ADDENDUM NO. 3

**TO THE PLANS AND BID DOCUMENTS FOR THE UNIT 4 PHASE 2
COMPOSITE LINER CONSTRUCTION PROJECT
AT THE MID-VALLEY SANITARY LANDFILL
in Rialto, California**

January 26, 2026

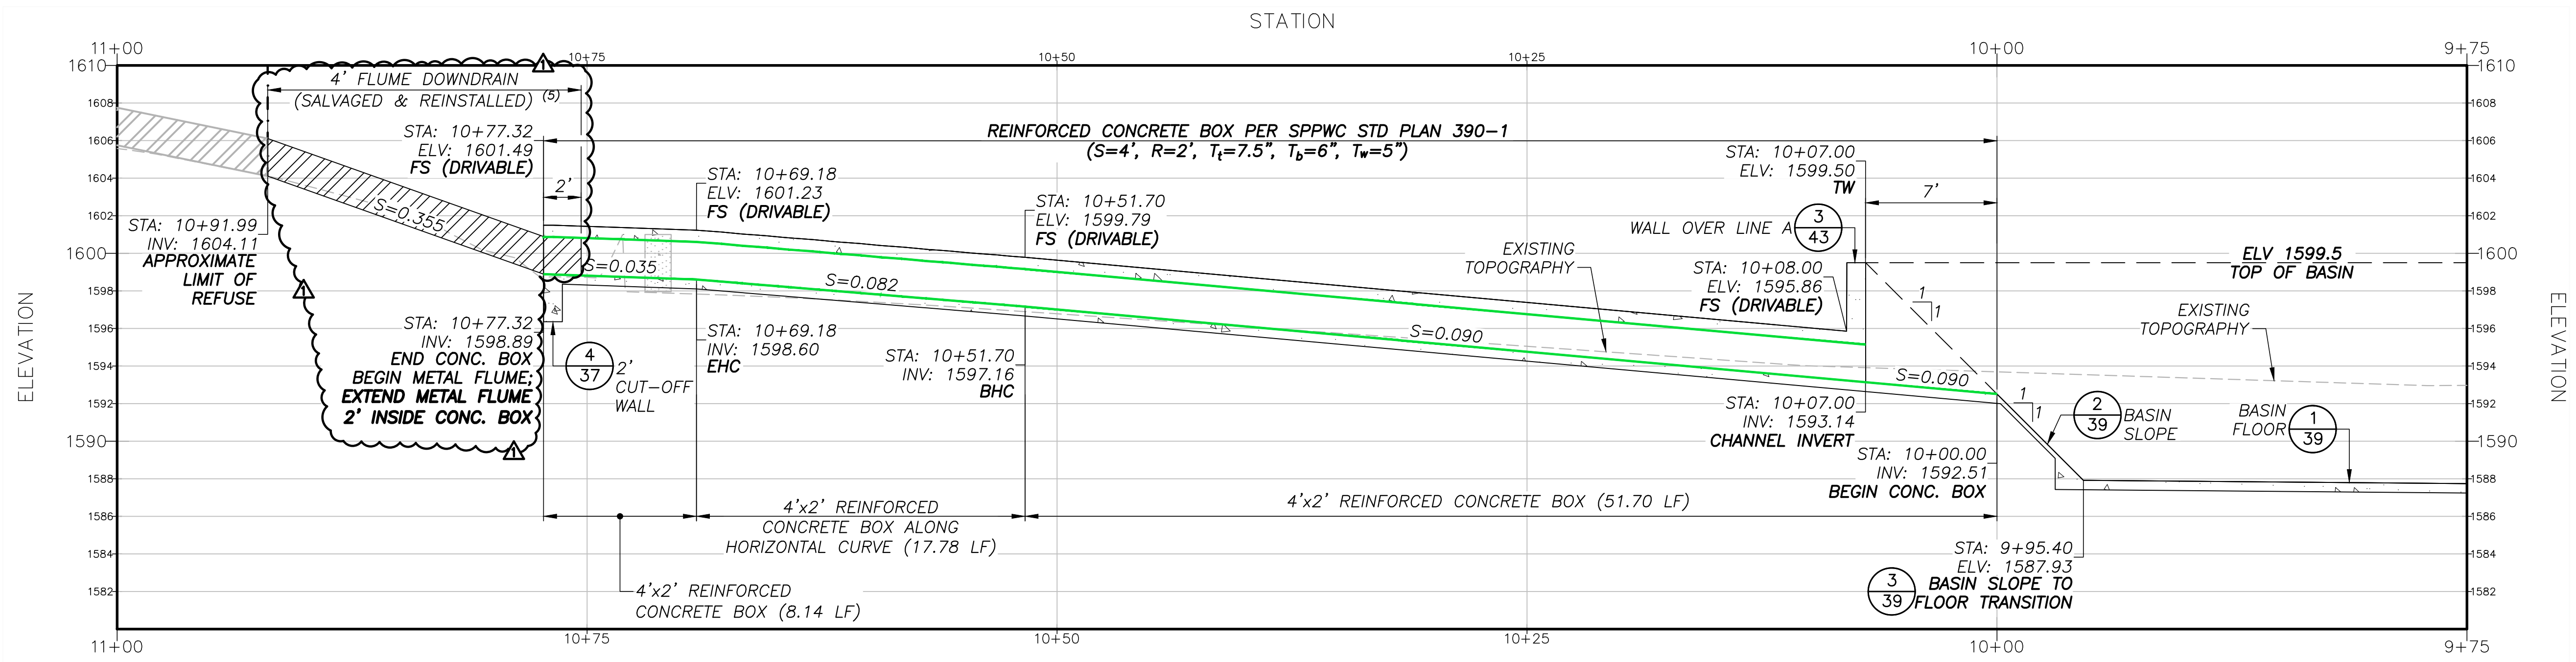
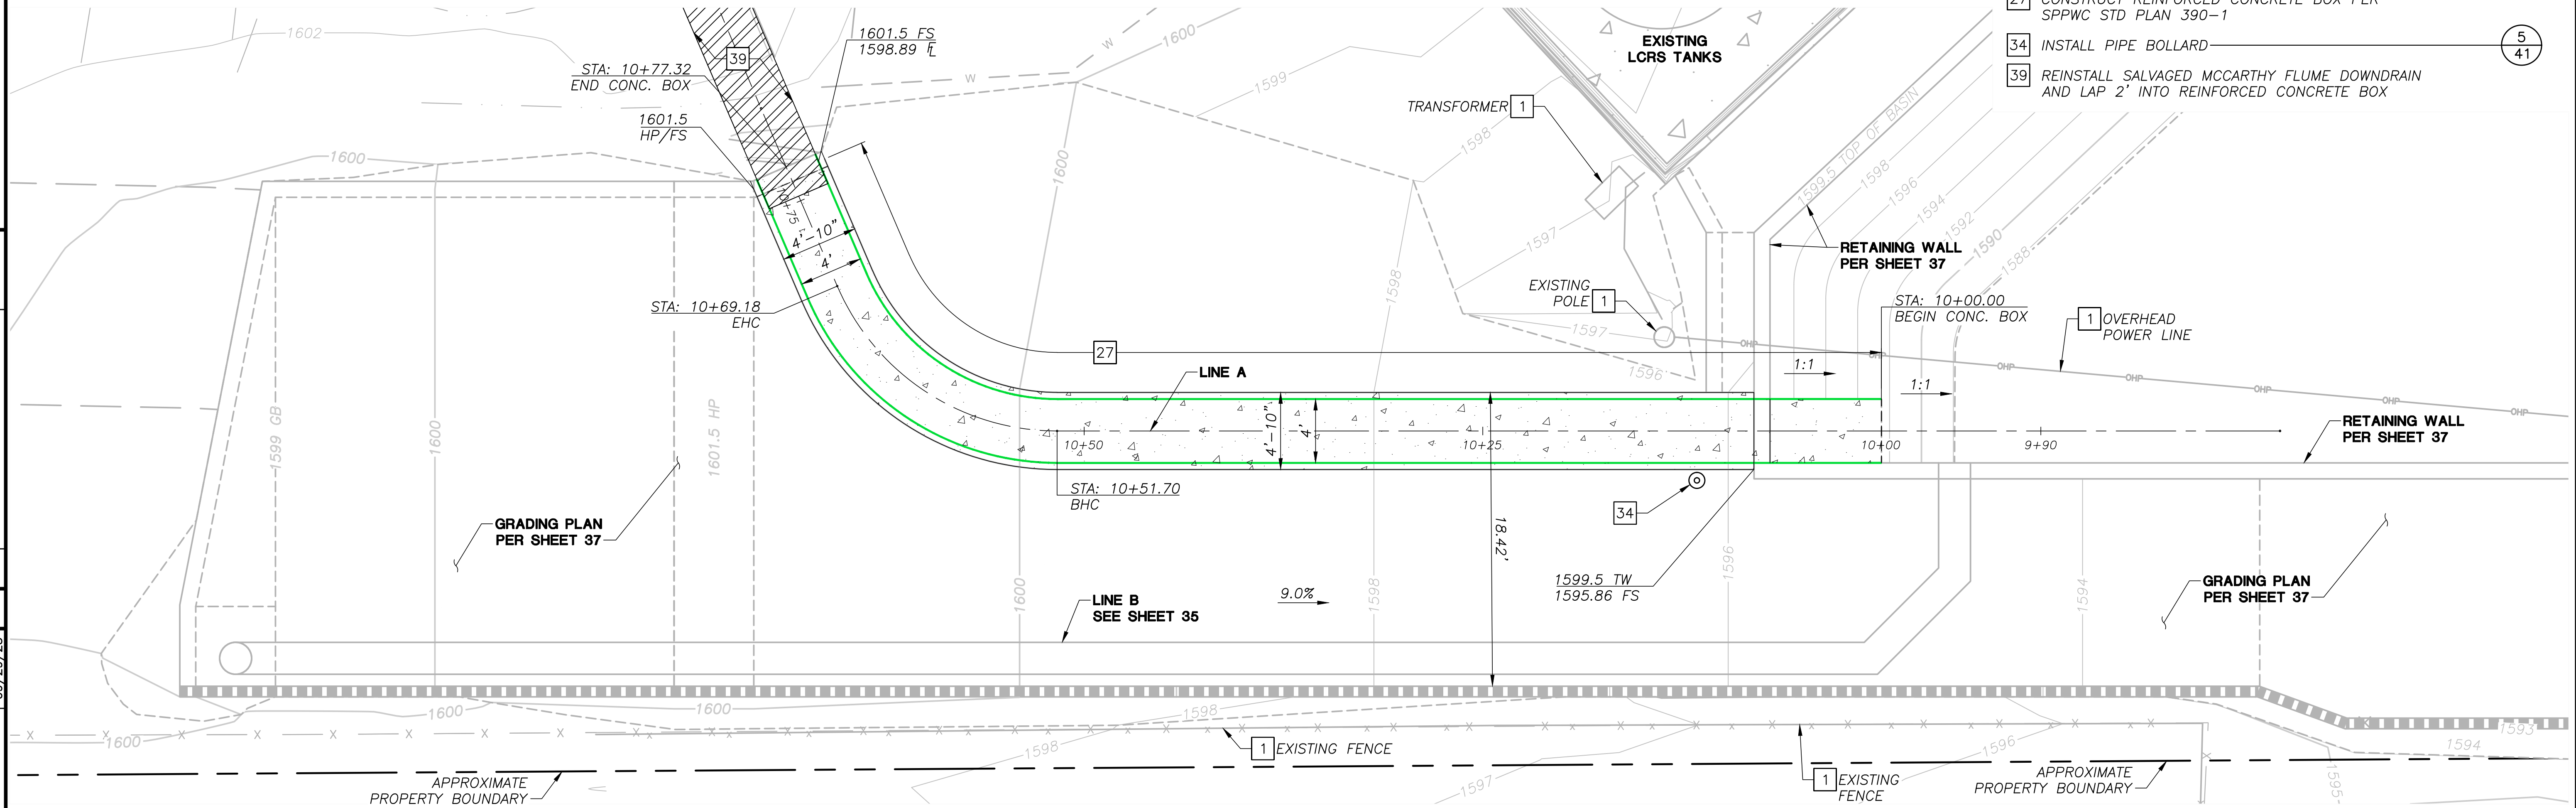
Q20. On Sheet 34 (Unit 3 BMP Line A Profile), the 48-inch downdrain is shown tying in flush at the RCB flowline. Given that the RCB is only 2 feet tall, please clarify how this connection is intended to be constructed. Specifically, is a concrete anchor or transition required to support the remaining pipe height as it tapers into the RCB?

A20. See updated Sheet 34 reissued as part of Addendum #3. The existing downdrain flume is 4' wide, 2' tall and is intended to be placed approximately 2' into the proposed RCB per construction note 39. No additional anchor is required. The reinstalled flume shall be installed with salvaged joint restrains and channel joints.
